Alexander Schleicher
- Segelflugzeugbau -
Poppenhausen/Wasserk.

Modification No. 3
Glider K 8 a. K 8 B
(US 7G4)

Changing of the middle elevator bearing support.

LTA Nr. 17

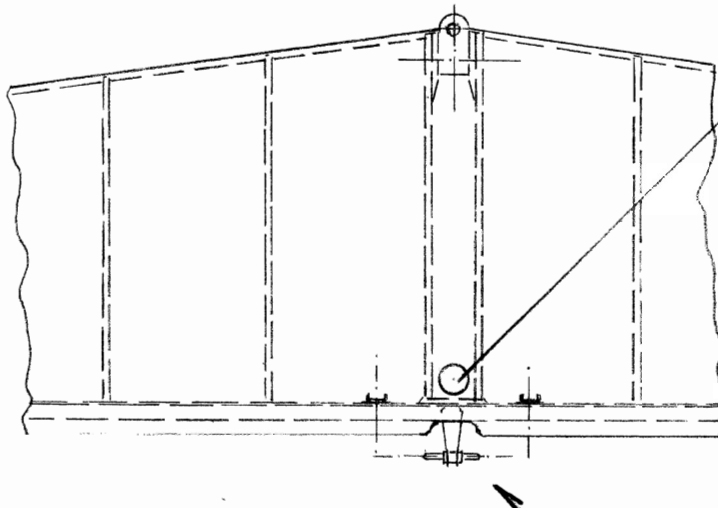
The bearing support of an aircraft cracked along the weld due to excessive grinding of the ground plate.

- 1.) Check the middle bearing support for cracks or grinded weld on the ground plate.
- 2.) Order a new bended support from the firm of Schleicher, Poppenhausen / Wasserkuppe, Germany.
- 3.) Changing of the support see sheet nb. 2

Correct drawing
L-216. 36-S 1

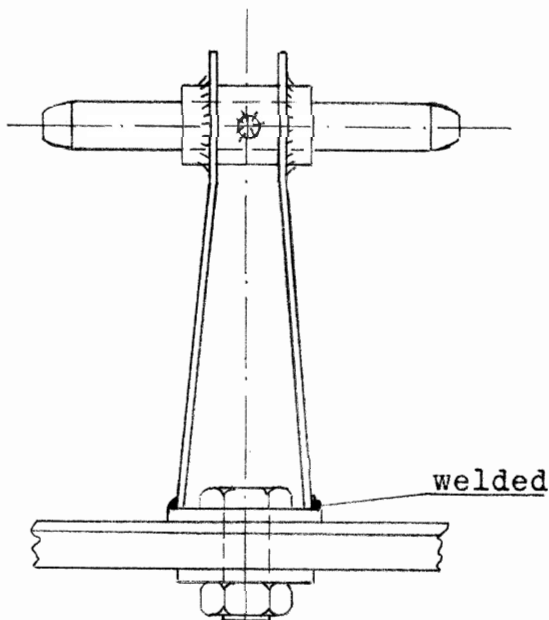
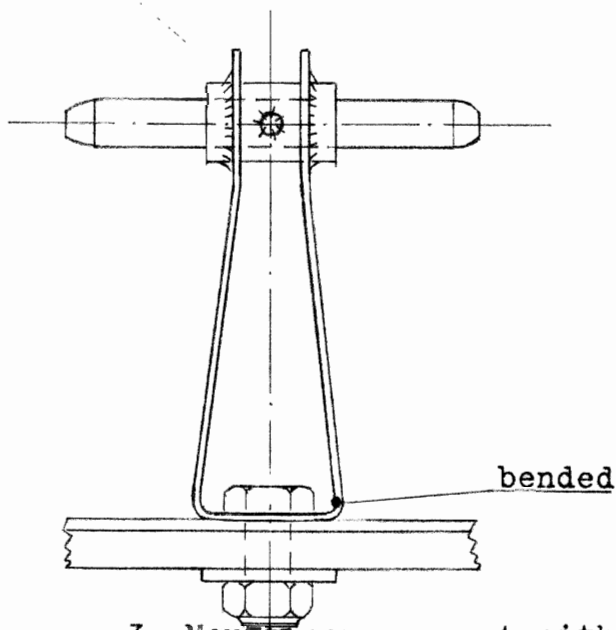
1. Cut in a hole into the plywood covering on the lower side.

4. Close later the hole with 0.04 " plywood.

2. Remove the old support.

3. Mount new support with new screws and nuts. Notice: No bearing thread, cut thread exactly.
